**16 - 19 October, 2001****Sydney, Australia**

**Title:** Liaison Statement on HFN Reset and THRESHOLD**Source:** S3**To:** RAN2**Cc:****Response to:****Contact Person:**

## CHANGE REQUEST

Title: Security concern with HFN reset procedure

**Figure 11.4: RLC reset procedure**

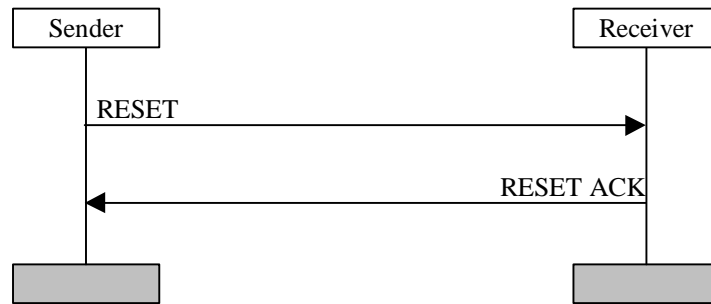
All RLC Control PDUs, including RESET/RESET ACK, are not ciphered and are not integrity protected. The RESET and RESET ACK are always associated to an AM RLC entity and they carry the HFN value to be used in the UL COUNT-C. Both UE and UTRAN can initiate a RESET procedure by sending the RESET PDU. The receiving entity will then send a RESET ACK PDU. We can envisage a multiplicity of security threats that could take advantage of this procedure:

- *Denial of service attack.* A third party can transmit a RESET PDU with an incorrect HFN. The RESET ACK PDU response will be ignored by the supposed sender. From then on, decryption of the packets will result in incorrect and unintelligible data being received, but since there is no integrity check, the lower layers cannot detect or recover from the situation. Furthermore, by setting a large HFN, past the threshold, a new AKA might be triggered, resulting in exhaustion of Authentication Vectors, delays and excessive network traffic.

- *Exposure of HFNs.* If an eavesdropper is recording the call from its beginning he will be able to deduce the HFN values used in COUNT-C. But if he starts recording it while in progress, or if he loses part of it due to bad radio conditions (quite a likely scenario), he may lose track of the current value of the HFN and therefore he will not be able to reconstruct COUNT-C. However, he could take advantage of the RESET procedure to read the correct HFN values being sent in the RESET/RESET ACK PDUs. By the way, to cause a RESET for a "man in the middle" is very simple. He only has to change the sequence number (always in clear) to a value that is outside of the "expected" window of sequence numbers.

- *Rogue equipment can avoid re-authentication.* The COUNT-C value triggers re-authentication when it exceeds the threshold value. But non-conforming equipment can reset the HFN "backwards" so that its COUNT-C never reaches THRESH. This partly avoids re-authentication (it might be triggered by the HFN in the other direction) and at the same time compromises privacy by reuse of COUNT-C values.

1. The HFN values should not be sent in clear and without integrity protection.
2. If HFN have to be re-synchronized, the new values should grow monotonically; while this is specified behaviour for a conforming transmitter, no provision is made for it to be checked in the receiver. Provision should be incorporated for the re-synchronization procedure to fail or be refused.

**Figure 16c: The structure of COUNT-C for all transmission modes**

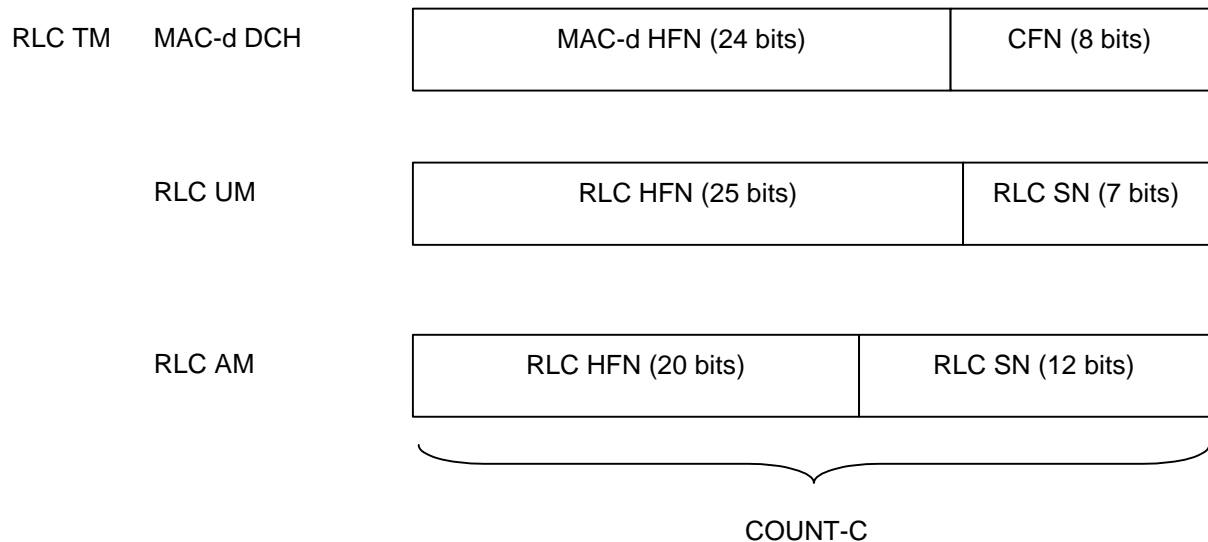
Note that RLC Sequence Numbers (SN) are always sent in clear over the air (Uu interface) both in Uplink and in Downlink.

Figure 9.6: RESET, RESET ACK PDU

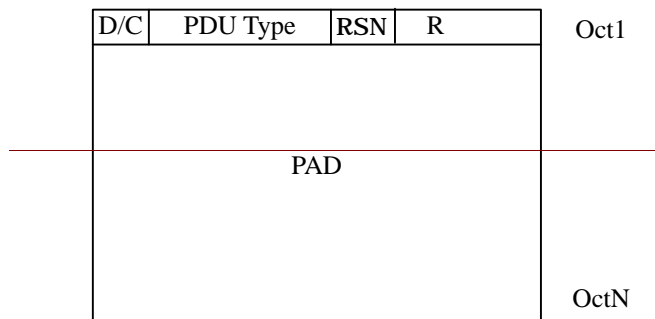
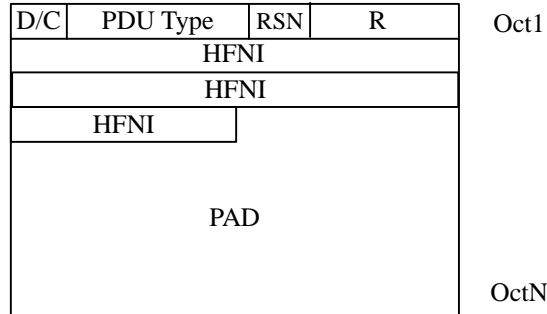
- The current RLC reset procedure can lead to unsynchronised hyper frame number (HFN) values between UE and UTRAN, which will lead to ciphering failure as discussed on the email reflector. To correct this mechanism, HFN values are indicated in the RESET PDU and RESET ACK PDU. With this correction, RLC can maintain synchronisation of HFN values during reset.
- [Minor editorial updates after RLC-adhoc has been made in 11.4.1.](#)

The RESET PDU and RESET ACK PDU has a one-bit sequence number field (RSN). With the aid of this field the Receiver can define whether the received RESET PDU is transmitted by the Sender for the first time or whether it is a retransmission of a previous RESET PDU..
